ROUTER

FIELD CHANGE NOTICE

PRODUCT: CMI / MFX

ASSEMBLY No. ESPRT1 DESCRIPTION ROUTER

Title ESP-R12 - HPF and Control Logic
 Size Document Number B
 Revision 1 of 2
 Date: June 4, 1991
 File: R12.SCH

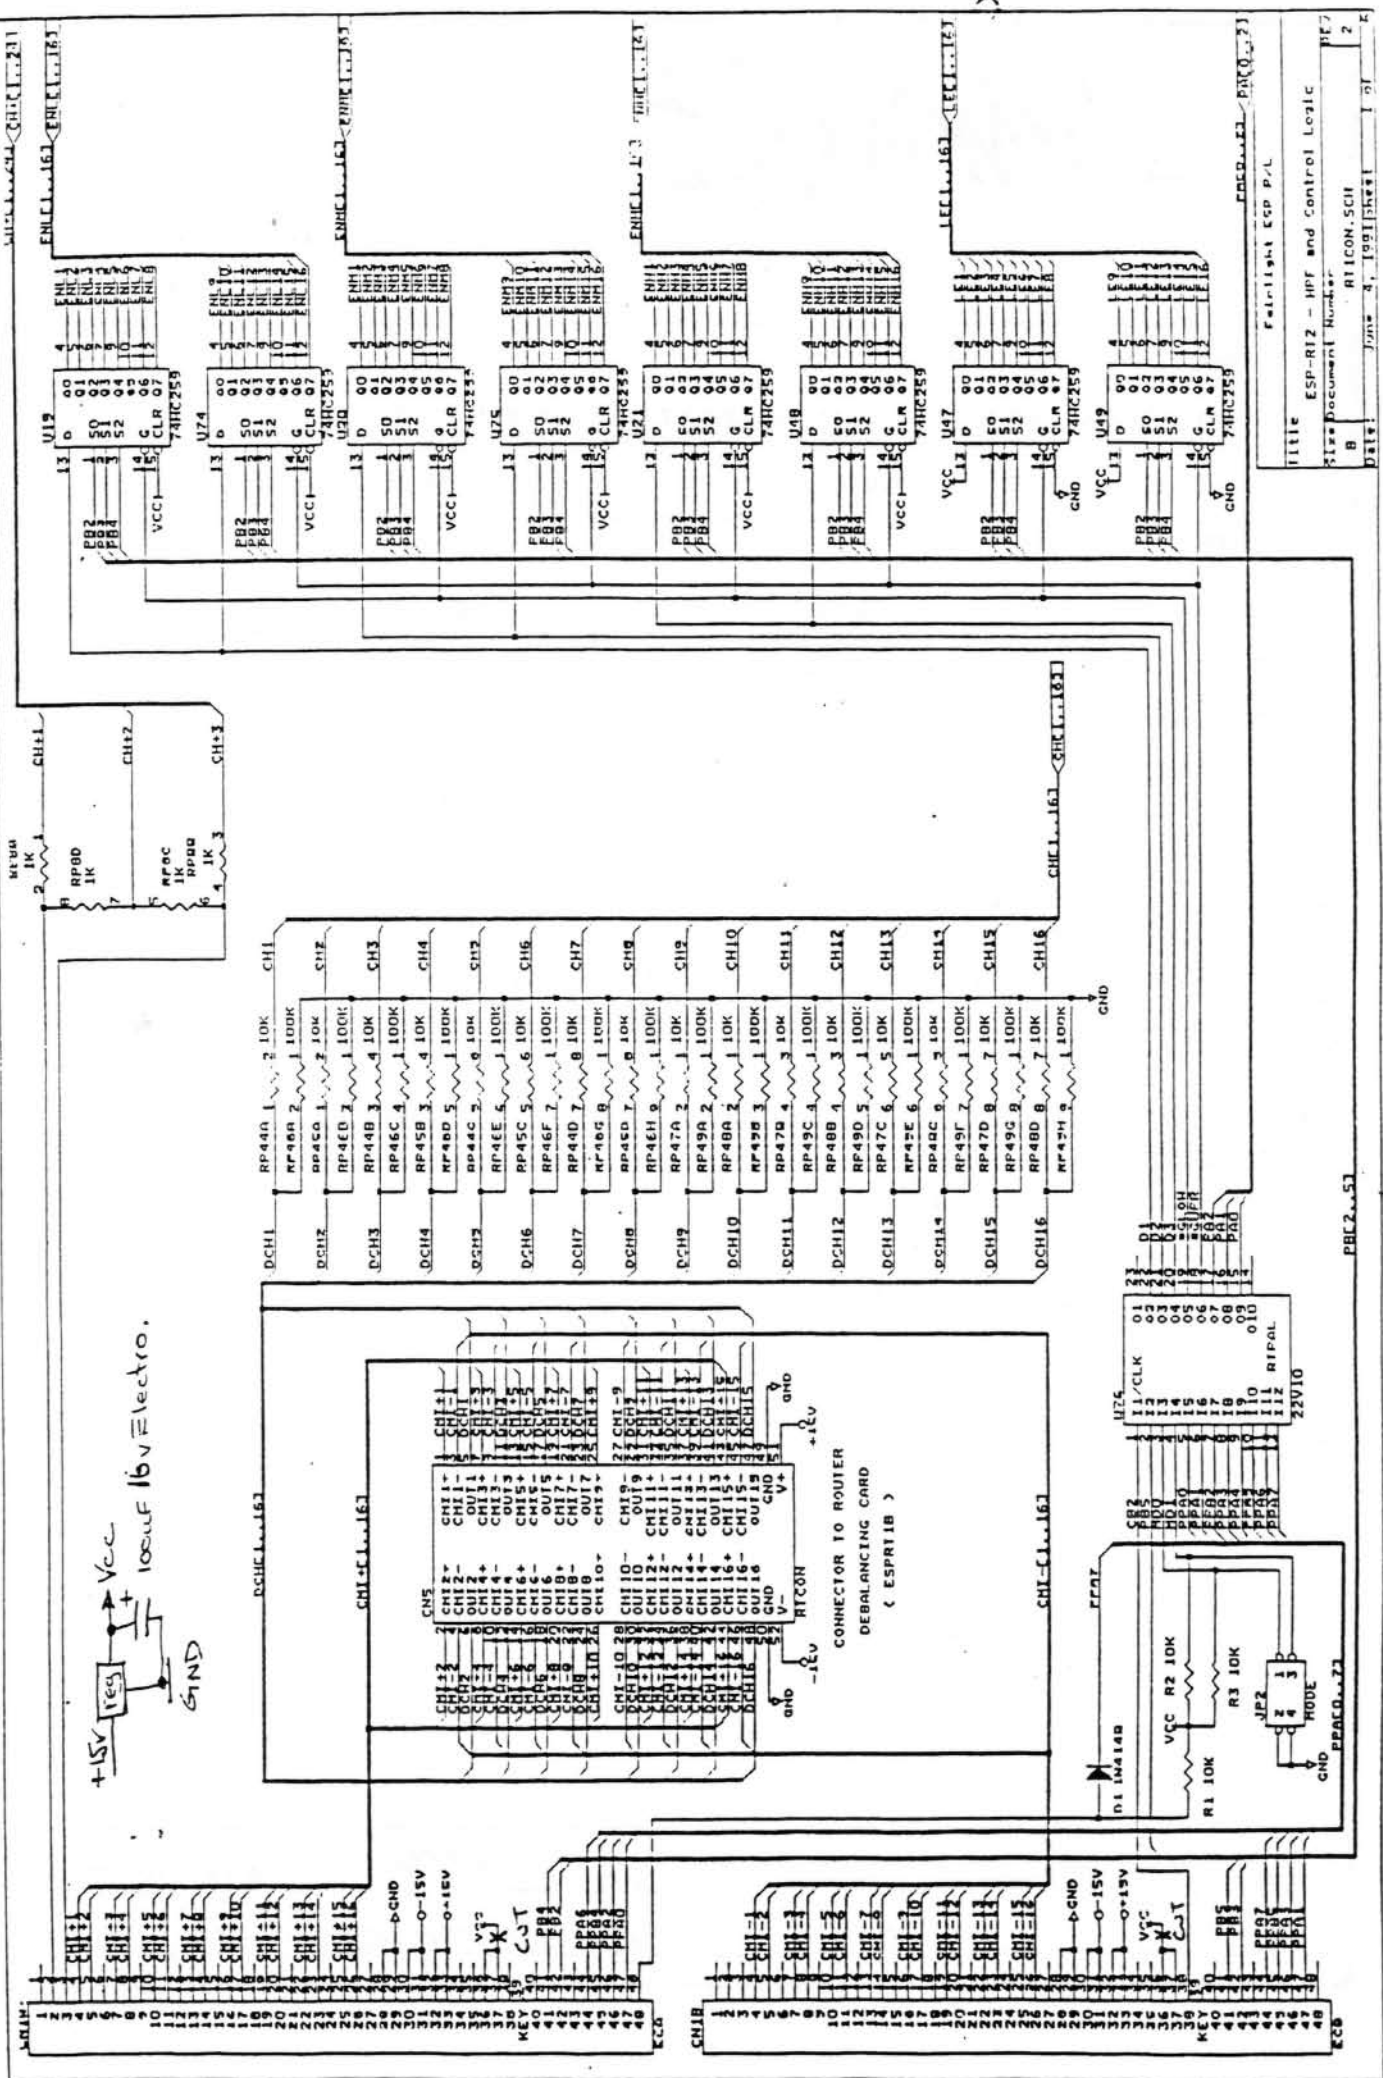
REASON FOR CHANGE:

SCSI / Data noise on router outputs.

Replacing the +5V digital voltage (VCC) with +5V regulator voltage from +15V analog voltage.

1. Cut Tracks from edge connector pins A36, A37, B36, B37 (+5V input) These tracks are on either side of pcb.
2. Connect input pin of 7805 (Use T0-220 type) regulator to +15V pcb track. Edge connector pins B32,B33.
Scrape the pcb clean of solder resist and tin. This should be done on the component side of the pcb OR use the feed thru hole.
3. Connect the center pin of the regulator to 0V audio (GND) with a short piece of wire. Edge connector pins B28, B29. Scrape the pcb clean of solder resist and tin.
4. Connect output pin of the regulator to the component side of the pcb track cut (Vcc). Scrape the pcb clean of solder resist and tin OR use the feed thru hole.
5. Add 100uF 16V capacitor from the 0V (GND) to the +5V output pin of the regulator.
- 6 Check all connections and track cuts before switching on.
7. Label the board Rev 2.3.

Title	ESP-R1B DIFFERENTIAL AMPLIFIERS
Size	Document Number
B	ESPRTIB1.SCH
Date	June 17, 1991 Sheet 1 of 4

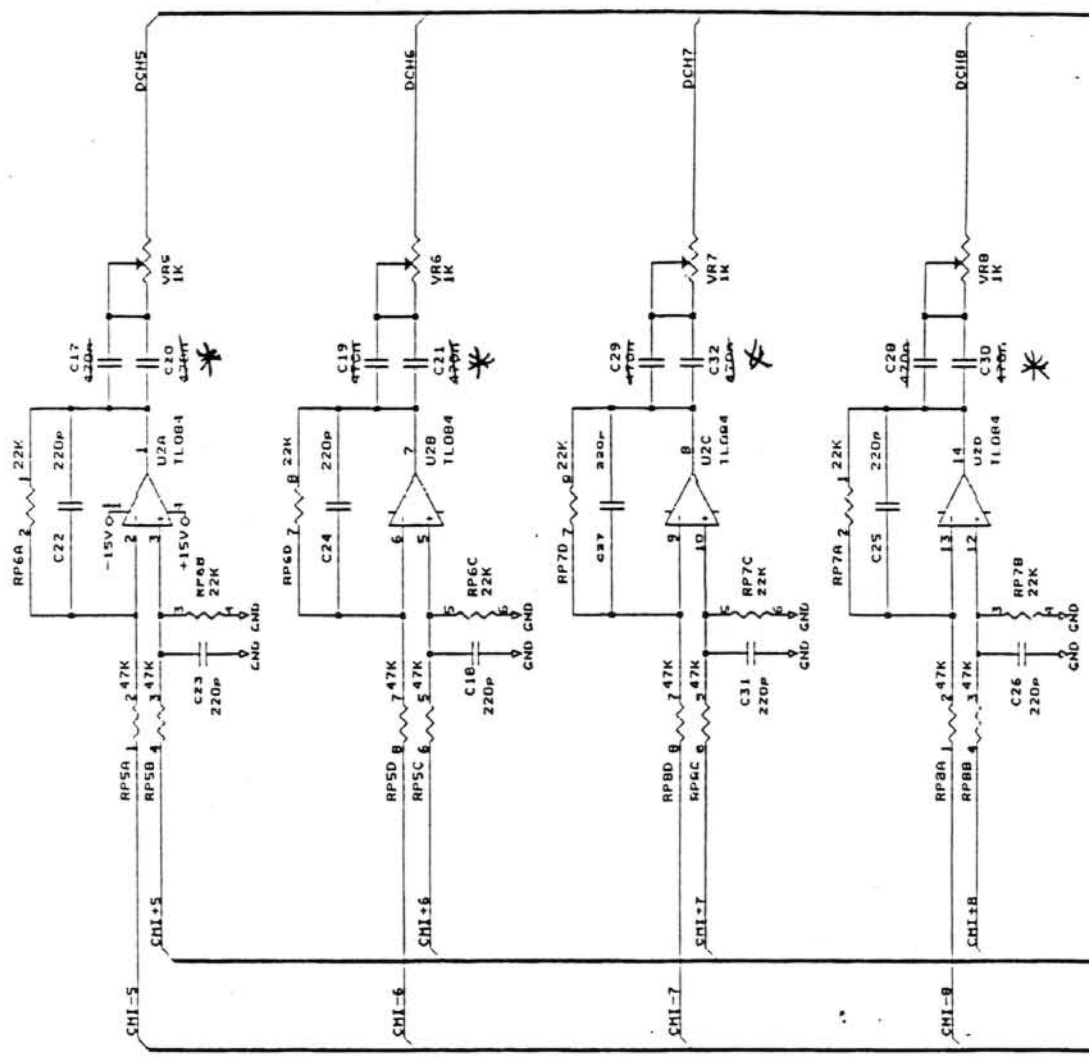
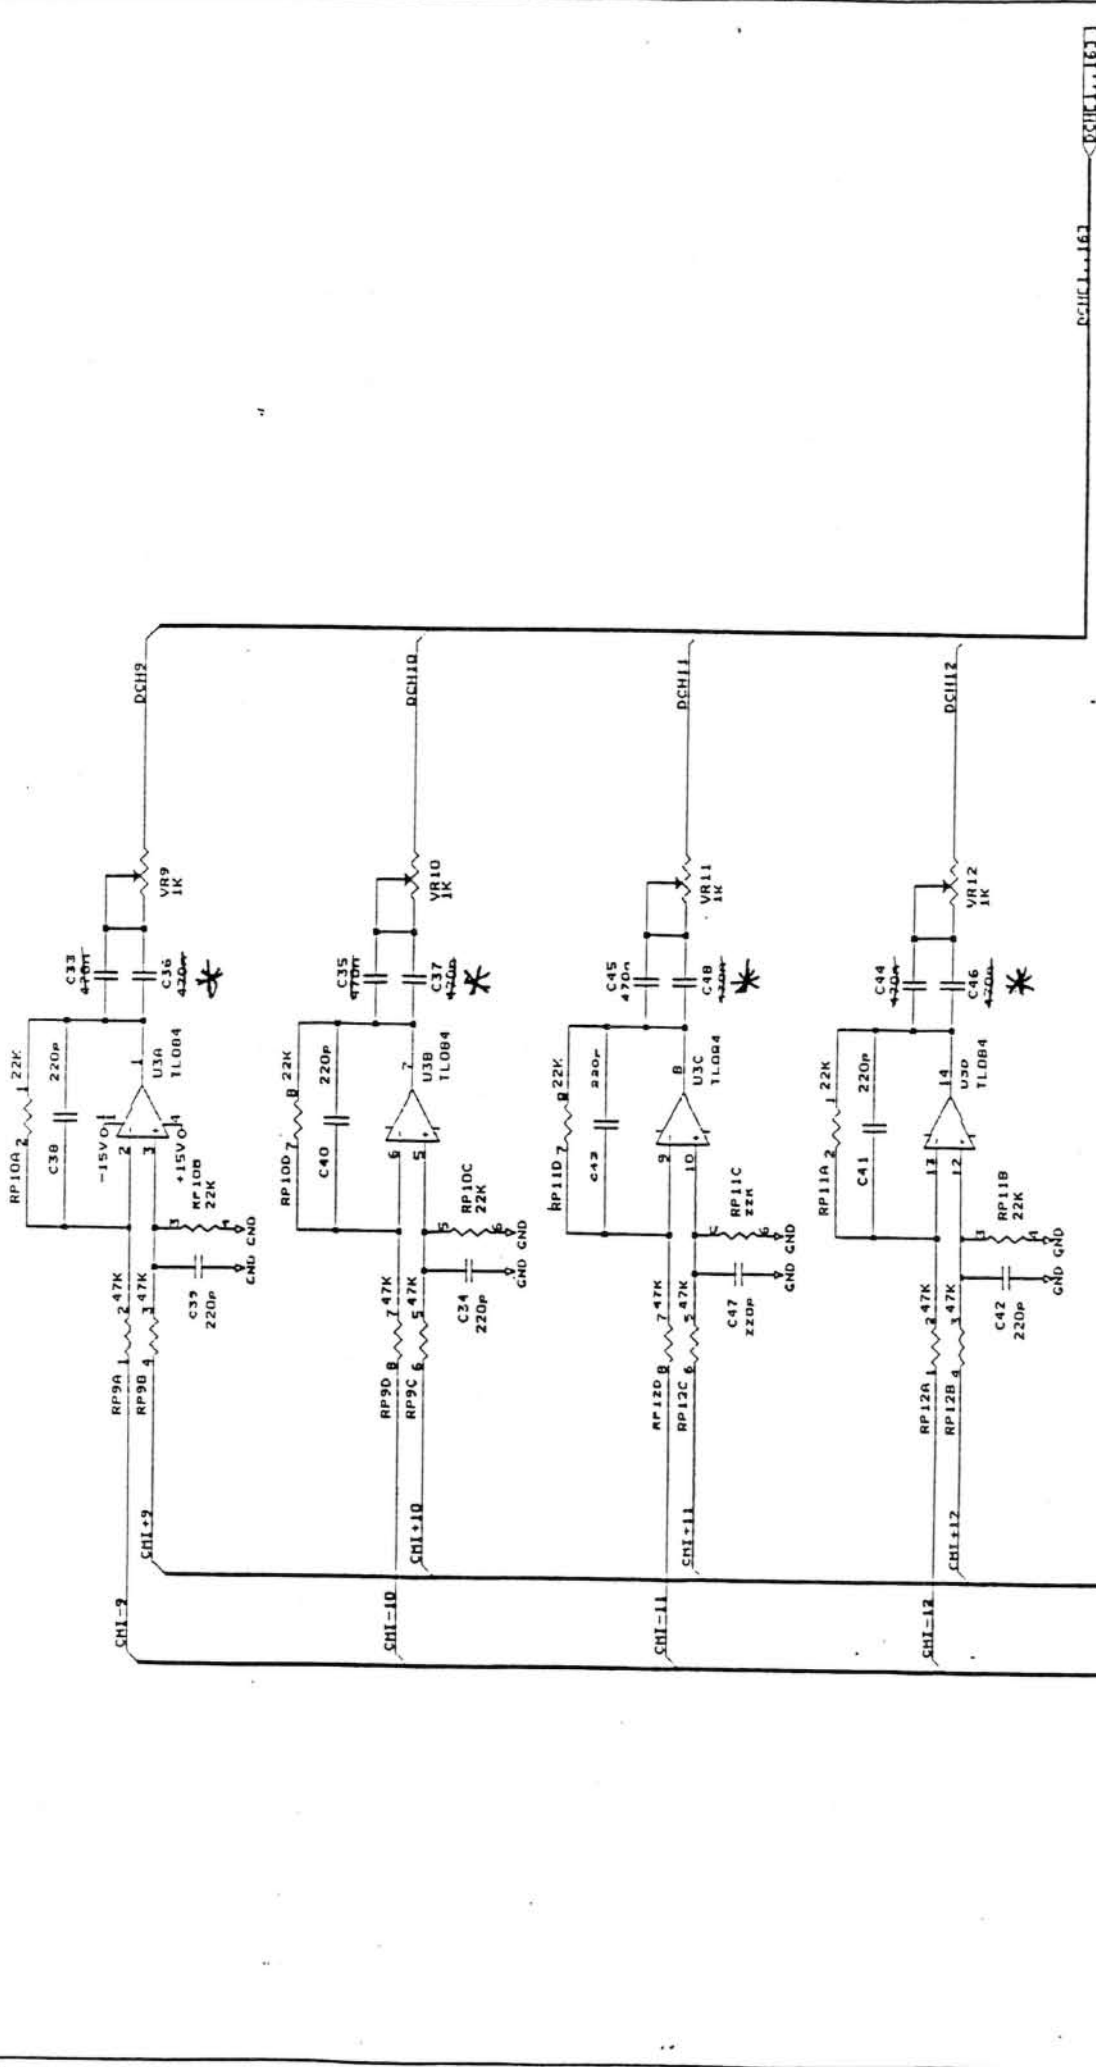
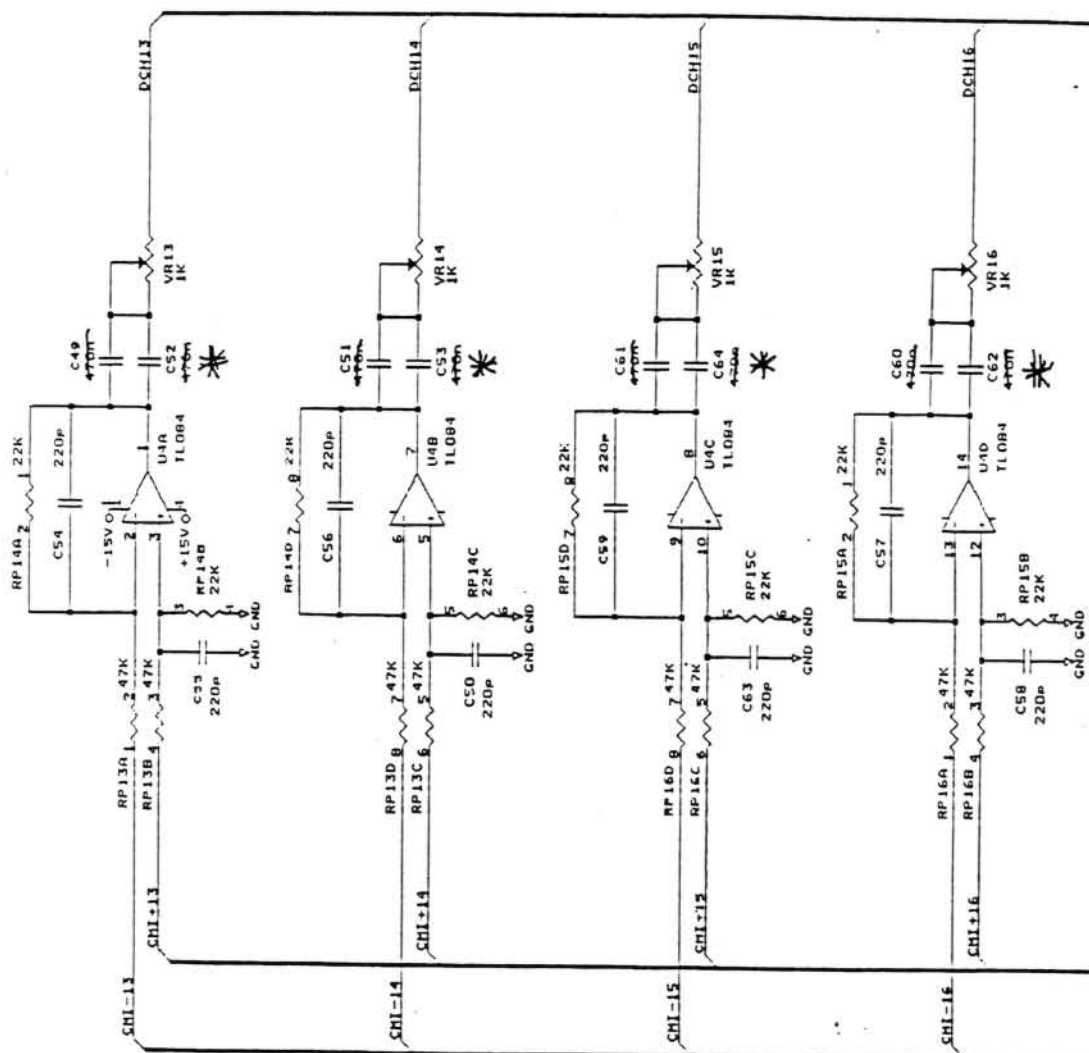
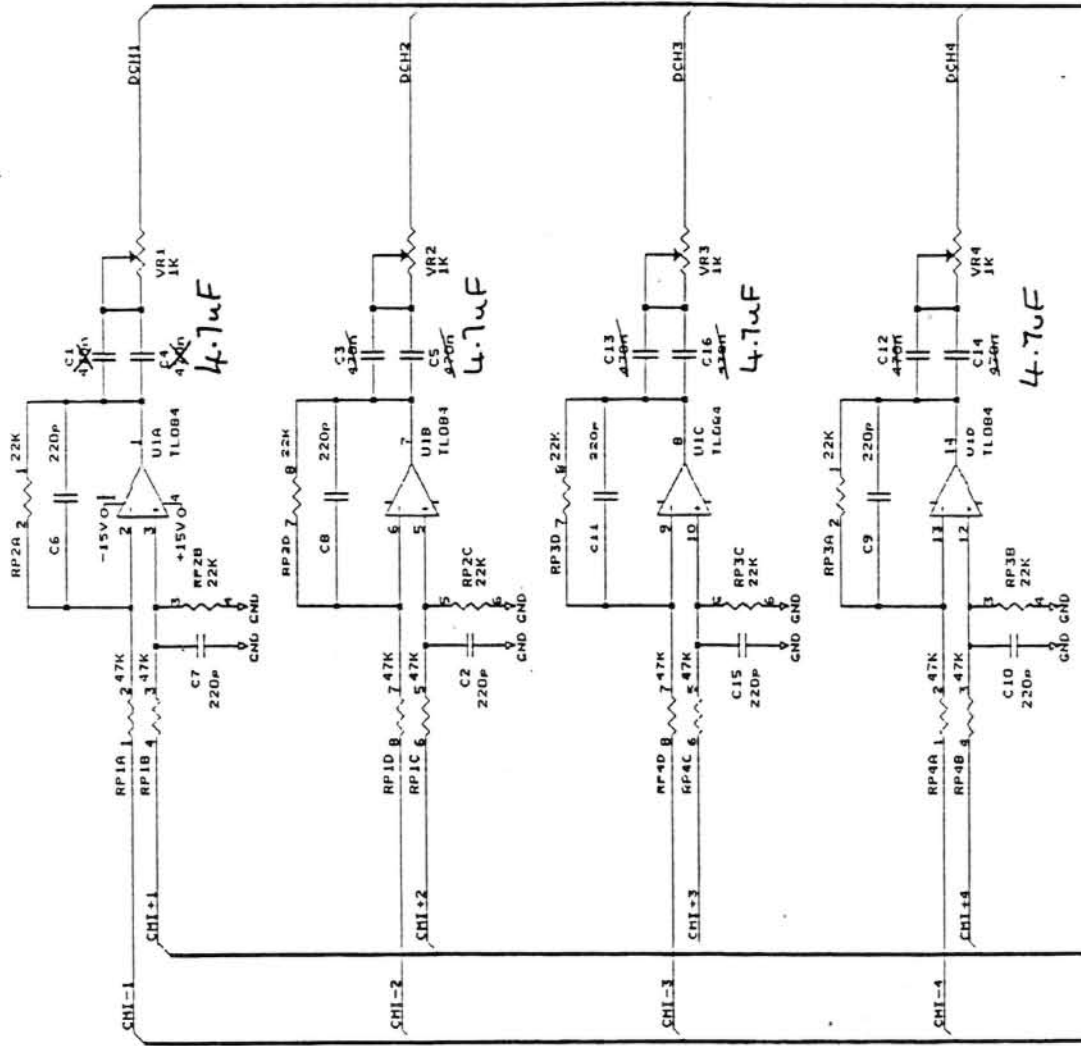
REASON FOR CHANGE:

To eliminate D.C.. off set at the output of the de balancing amplifiers on the top router board (RT1B REV 2 pcb).

The D.C.. offset is heard as a click at the beginning of a clip i.e. when a channel is routed to a track output.

Earlier revisions of the router did have capacitors installed in the output. These were 2 x 470nF in parallel. If this is the case remove 1 of the 470nF and replace with 4.7uF 25V non polarized capacitor.

Later revisions of the router had both the 470nF replaced with links. If this is the case remove both links and install 1 x 4.7uF 25V non polarized capacitor.

See circuit for the reference. Note capacitors are in parallel

C1,3,4,5,12,13,14,16,17,19,20,21,28,29,30,32,33,35,36,37,44,45,46,48,49,51,52,53,60,61,62,64.

* 4.7uF 25v non Polarized.
